### STATE VARIANCE FORM

TOWN/CITY CODE <u>11020</u>	LPI NUMBER <u>360</u>	DATE PERMIT ISSUED <u>4-28-82</u> <small>MONTH DAY YEAR</small>	EVALUATOR NUMBER <u>75</u>	PERMIT NUMBER <u>48513ES</u>
ADDRESS OF SYSTEM'S LOCATION				
<u>Lot No. 6, Dostie Bros. subdivision,</u>		<u>Eight Rod Rd.,</u>		<u>Augusta, Me.</u>
<small>ST/LOT NUMBER</small>		<small>STREET, ROAD NAME/SUBDIVISION</small>		<small>ZIP CODE</small>
<u>Gabriel Dostie</u>		<u>RFD 3, Box 19</u>		<u>Augusta, Maine 04330</u>
<small>NAME OF OWNER</small>		<small>MAILING ADDRESS</small>		<small>ZIP CODE</small>

# • SEWAGE DISPOSAL BED DETAILS •

Subject: Variance to the Maine Plumbing Code, Part II, Gabriel Dostie property,  
Lot #6, Dostie Bros. Subdivision, Eight Rod Road, Augusta

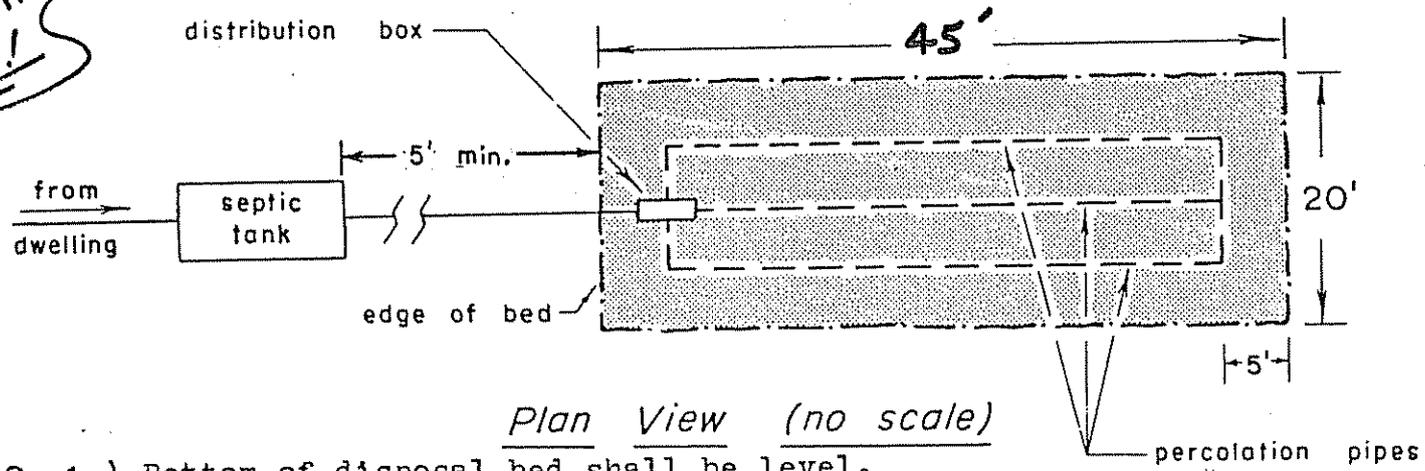
An on-site inspection was made in April, 1978 to the subject lot by Mr. Albert Frick, Soil Scientist, and Mr. David Breau, Assistant Engineer for this office. During the on-site, Mr. Noble's soils report was verified, and it was the determination of this office that the mottling observed was not a true indication of the seasonal high water table and that a system could be placed on the property provided a two foot separation was maintained above the elevation of the flattened area at the base of the hill to the rear of the property and the bottom of the disposal area.

The installation of a 1000 gallon septic tank followed by a 45'x20' bed system.

At least 1 inches and 25 inches of fill shall be applied on the uphill and downhill sides of the disposal field, respectively. The fill shall be of a texture similar to the original soil and will provide a 24 inch separation between the bottom of the disposal bed and the seasonal high water table and impervious layer. The fill must be extended in all directions as required by Chapter 9 of the Maine Plumbing Code, Part II.

Subsurface Absorption Area Cross-section

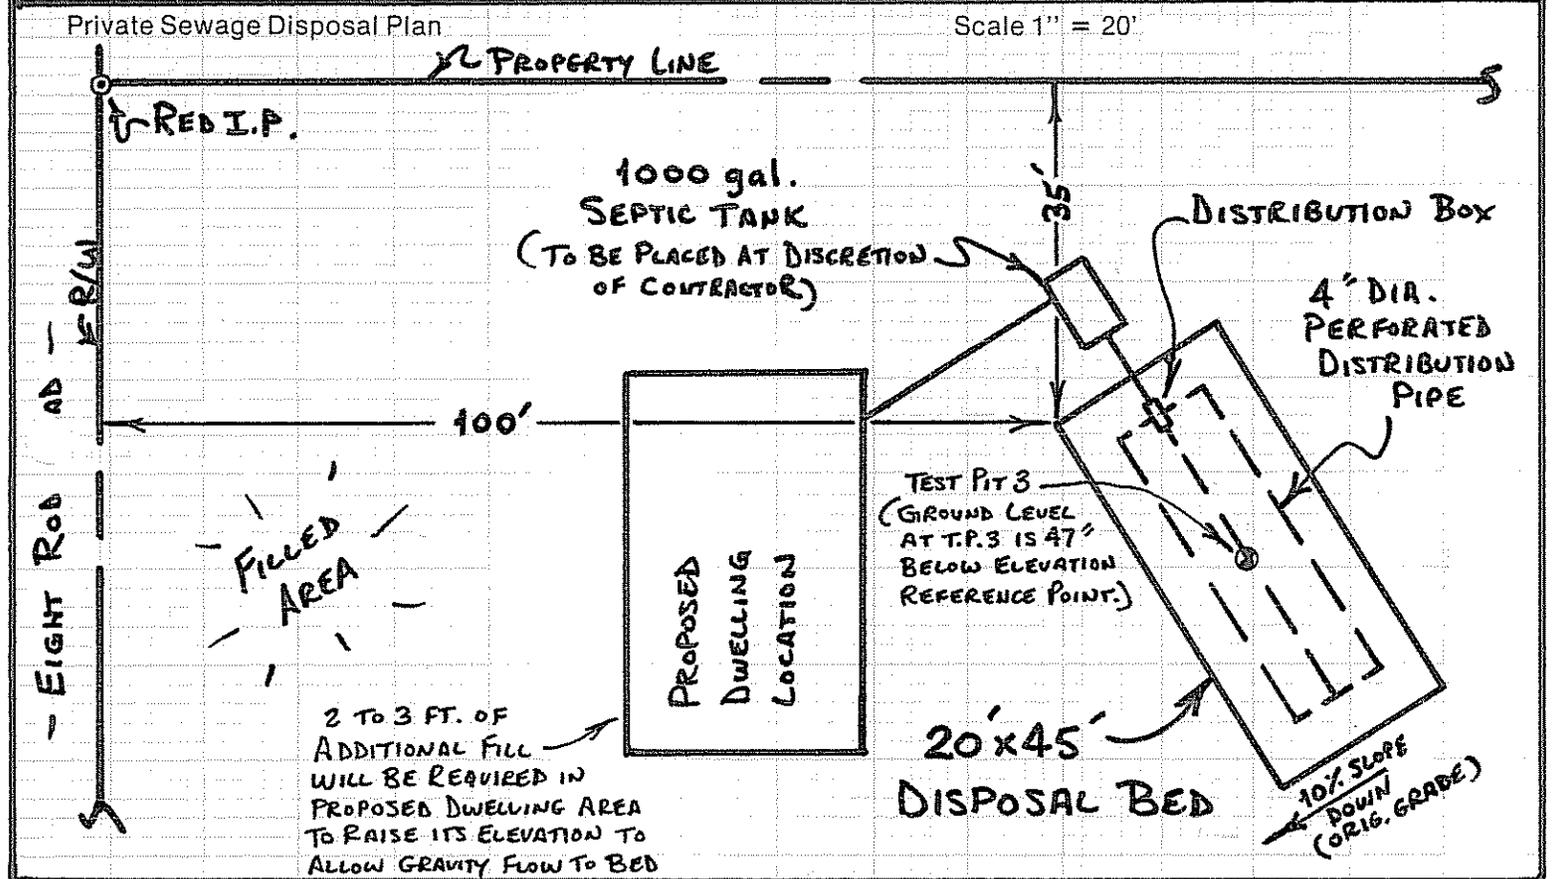
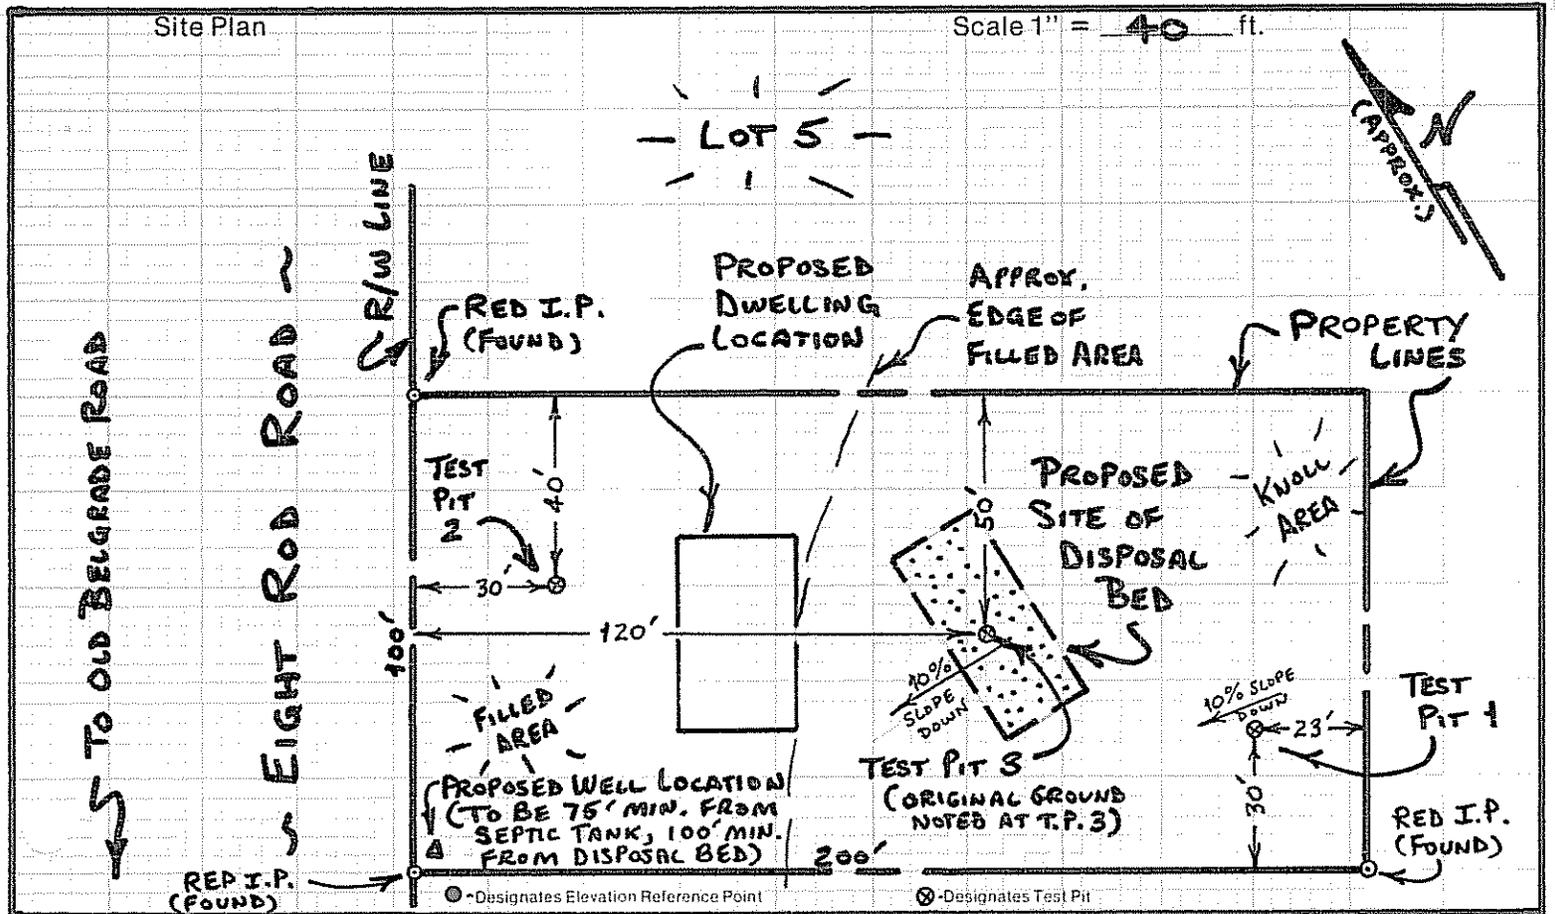
- MANY AREAS OF THIS LOT HAVE BEEN REWORKED (CUT AND FILL). TEST PIT 3 TAKEN IN UNDISTURBED AREA OF SOIL.
- ELEVATION OF DISPOSAL BED BASED ON ACTUAL GROUND WATER LEVEL OBSERVED IN TEST PIT 3 ON 6 MAY 1979 (46" BELOW ORIGINAL GROUND LEVEL).
- DISPOSAL BED BOTTOM TO BE 24" MIN. ABOVE OBSERVED GROUND WATER LEVEL, OR 57" BELOW ERP.
- FINAL GRADE OF DISPOSAL BED CROWN AT CENTERLINE WILL BE 30.5" BELOW ERP (SILL OF YELLOW HOUSE).
